**Attachment A:
Predevelopment Plan Review
Comments to Applicant**

PREDEVELOPMENT PLAN REVIEW COMMENTS

Project Number: PPR2019-00008
Date: October 3, 2019
Project Address: 491-577 South Arroyo Parkway

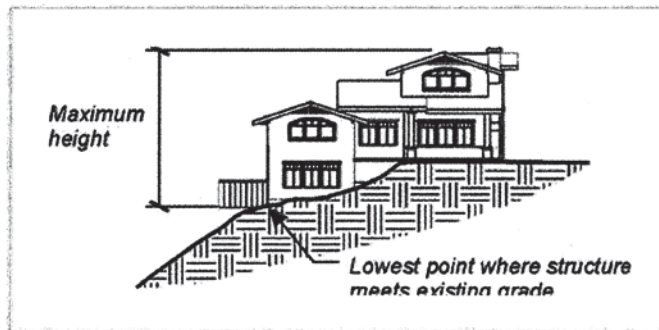
7. **Height (PMC 17.26.020.3.c(3) and 17.30.030)** Per the PD standards, in the CD district, no PD plan may authorize a greater height than that permitted by Figure 3-8 - Central District Maximum Height. The site is located in the CD district and Figure 3-8 establishes a height restriction of 50' for the site.

The project proposes heights of up to 90' and exceeds the established height standard of the zoning district. Although a PD Plan allows an applicant to prescribe its own development standards, it is recommended that the PD Plan height standards be similar to the existing development standards of the zoning district. The maximum 50' height requirement for the Arroyo Corridor/ Fair Oaks subdistrict, is reflective of the existing character of the surrounding area.

district and Figure 3-8 establishes a height restriction of 50' for the site. The project proposes heights of up to 90'.
